# Review of technical decision for WorkSafe New Zealand

Ref: **GKT-GENC-REP-0004**  
Rev: **04**  
Date: **05 March 2026**  
Author: **Graham Kenyon**  
Status: **Published**  
Purpose: **Information**  
**Commercial in Confidence**

This report documents a review by an independent expert of the technical decision taken to list the deletion of Clauses 2.3.2.1.2(b) and (c) from AS/NZS 3000:2018 (including Amendments 1, 2 and 3) in Schedule 2 to the New Zealand Electricity (Safety) Amendment Regulations 2025. The report concludes that the decision is justified, but that there are residual risks. Some of the residual risks are already mitigated by existing practices, standards and guidance, whilst others require additional industry guidance and/or standards to be implemented.

Figure C.1 Example of path of possible diverted neutral currents

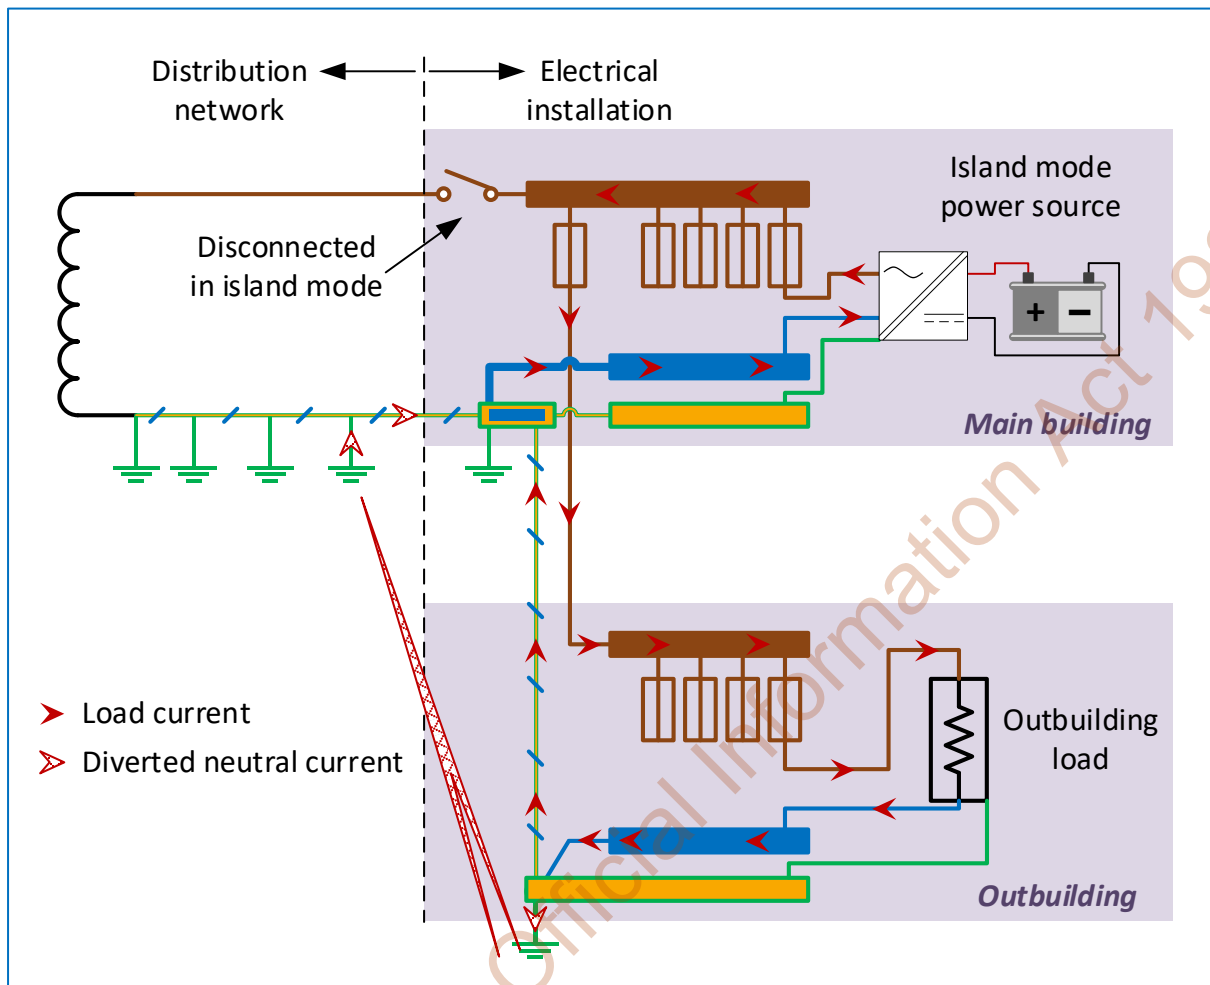
- C6-3 If the PEN conductor of the MEN network remains connected to an electrical installation operating in island mode, diverted neutral currents from PEN conductors in the installation can return to the island mode source via the MEN network as a parallel path, as illustrated in Figure C.1. This can provide a risk to persons working on the MEN system, even where the MEN system is de-energized for the work to be carried out.

- C6-4 Whilst the proportion of diverted neutral current in many cases is likely to be small with respect to load current, currents of only a few milliamperes can be fatal.

- C6-5 If the diverted neutral current results from shared metalwork (for example, metallic service pipes) between two separate electrical installations, however, a large proportion of diverted neutral current can be expected.

C6-10 The arrangement shown in Figure C.1 shows how a system referencing point effectively includes 'combining' of neutral and protective conductors from the perspective of the island mode source of supply. This is precluded in IEC 60364-5-54:2011+AMD1:2021 (see Paragraph E6-1 in Appendix E of this report). It is not clear how such a conflicting requirement might be interpreted in multi-source, or switchable-source, systems. Ideally, a PEN conductor should be used to connect the island mode source to the switchboard.
